9.5 BANKS RESERVE MASTER PLAN - NEXT STAGE OF IMPLEMENTATION

BANKS RESERVE MASTER PLAN
IMPLEMENTATION STAGE 2
 JOEL TERRACE, MOUNT LAWLEY

BANKS RESERVE PROPOSED FOOTBRIDGE FEASIBILITY STUDY

DRAWING TITLE
 IMPLEMENTATION PLAN

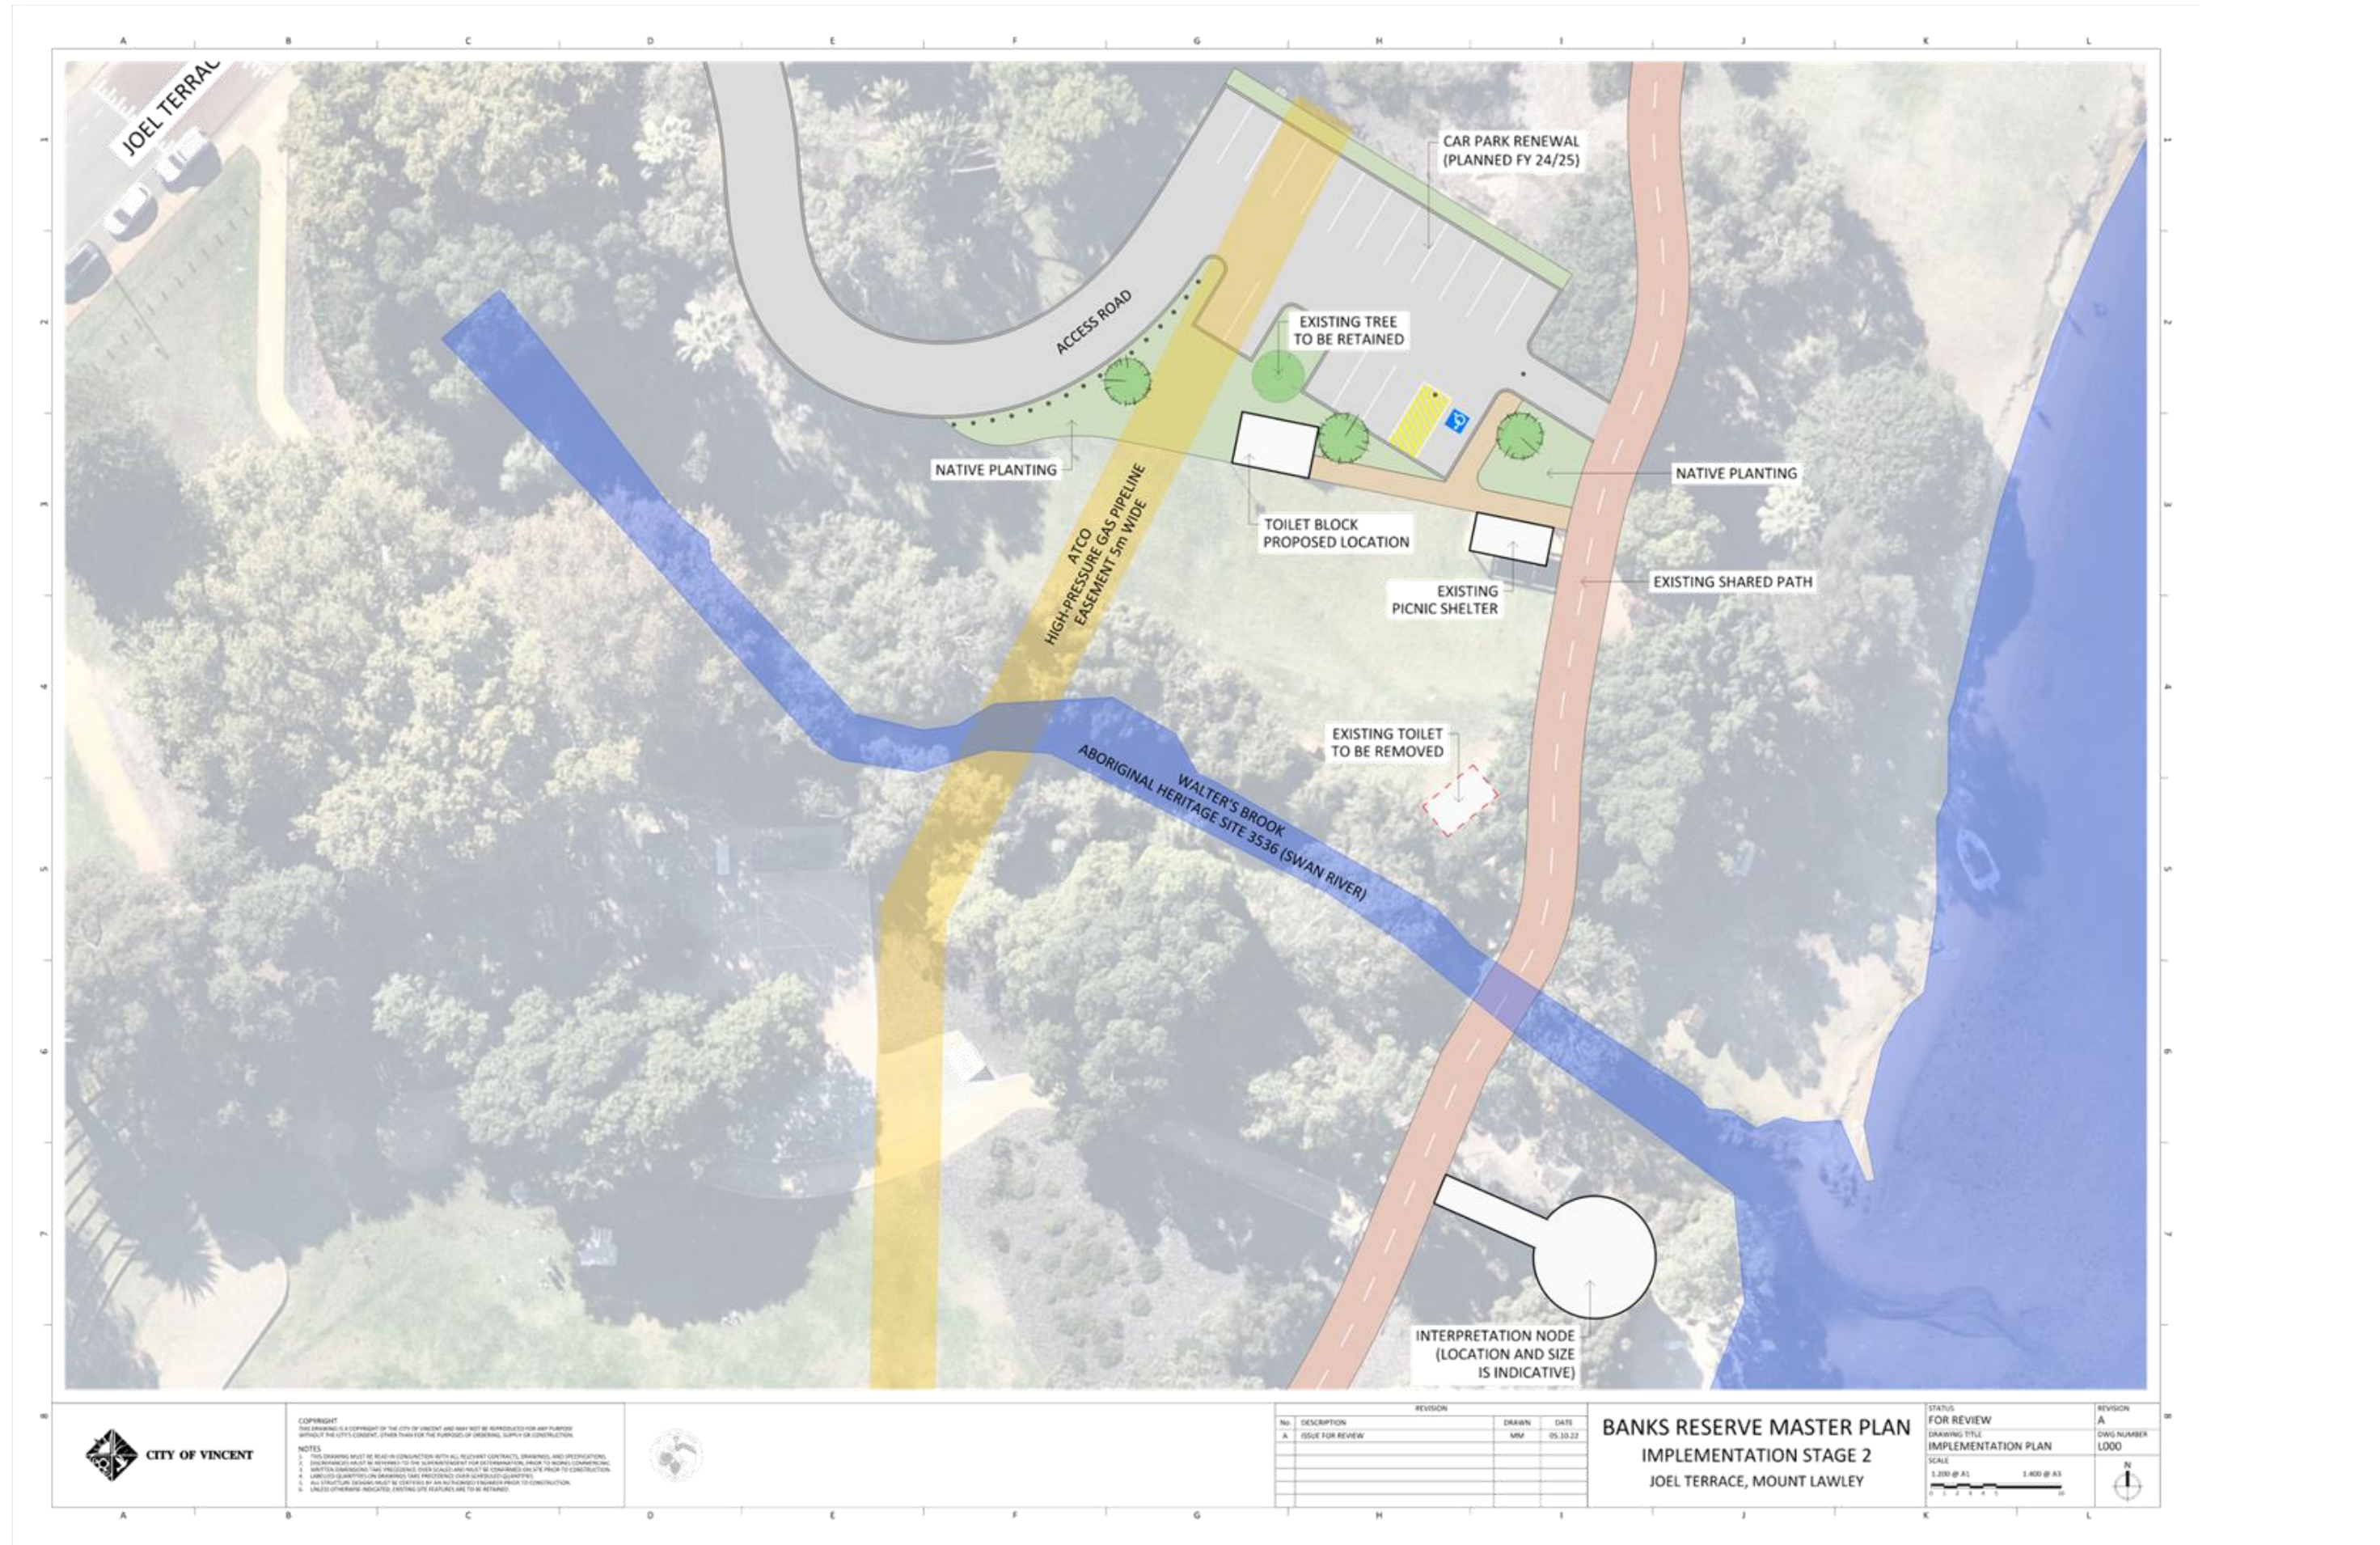
The location of the toilet block is shown at **Attachment 1**. This can be delivered within budget and achieves the following:

- Located approximately 20 metres from Walter's Brook (to better protect the Heritage / freshwater asset).
- Avoids the ATCO high-pressure gas pipeline easement (a restricted construction activity zone).
- Improved access and safety due to the proximity to the car park and separation from the bike path.
- Existing adjacent tree screens the facility for residents overlooking the reserve (from 102 Joel Terrace).
- Removing the existing toilet opens up the view to Walter's Brook and the view to the Swan River from the grassed area, providing new opportunities for interpretation and interaction by the public. This view to the Swan River was identified as a key consideration at a meeting with the City's Elders Group.

Detailed design of the structure itself will commence following confirmation of the budget allocation. A major part of DBCA's 'in-kind' contribution relates to this phase, with DBCA assigning a team of dedicated officers who will assist the City's Landscape Architect in designing the interpretation node. Preliminary site investigations with DBCA have identified a suitable location for the interpretation node, which is shown at **Attachment 1**.

Figure 1 OWCE Proposed Bridge Location

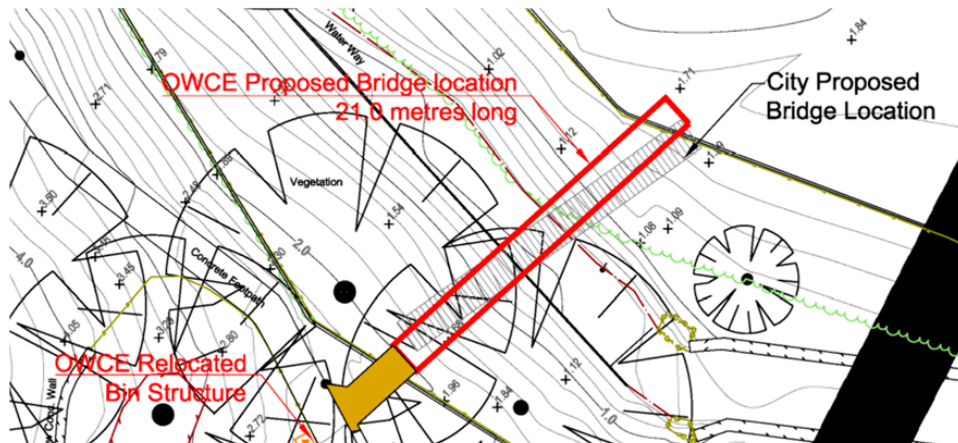
While the initial location nominated by the City is acceptable subject to further investigation, OWCE is proposing some minor adjustment to the bridge location to improve constructability as follows and as shown in Figure 1:

- Extend the south bridge entry by 1.0m and move approximately 1.0m to the east;
- Move the north bridge entry approximately 1.5m to the west.

The minor adjustments to the bridge location will move the south bridge entry 0.7m further away from the existing tree and will allow the foundations to be installed on flat ground further away from the top of bank. Moving the north bridge entry slightly to the west aligns the bridge closer to perpendicular to the waterway, moves the north bridge foundation further from the north top bank edge and further away from the existing drainage pipe discharging to the Waterway.

We highlight the OWCE location increases the bridge span from 20 to 21 metres and will require the relocation of the existing bin enclosure.

It is recommended the OWCE alternative location be accepted as a minimum.

Figure 2 Typical Bridge Elevation

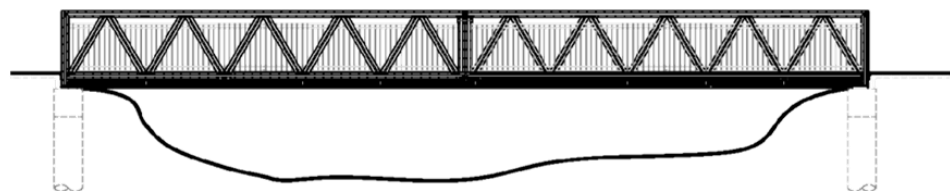
Steel truss bridges like the Landmark product are relatively light weight. The single span structure is supported either end tied to concrete foundation.

Typical elevation sketch for a steel truss bridge is shown in Figure 2 and Plate 7 shows a similar Landmark product recently installed in the City of Gosnells.
